14 October 2022

Product Change Notice

Part Series Affected: AP Series Cosmetic Change

Example of AP830 and AP851:

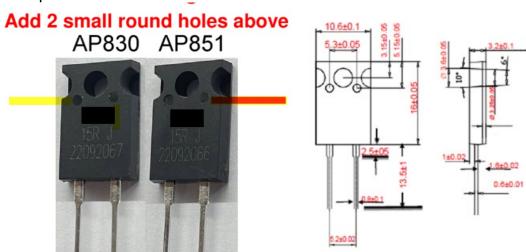
In response to the need for production expansion for select AP series resistors additional molding equipment is now in production. Parts made in the new equipment will have 2 small holes, 5.3mm apart, located below and to the left and right of the central mounting hole. The presence of these 2 small holes has no impact on form, fit, or functionality of the products. Both versions (with and without holes) will be used to fulfill orders.
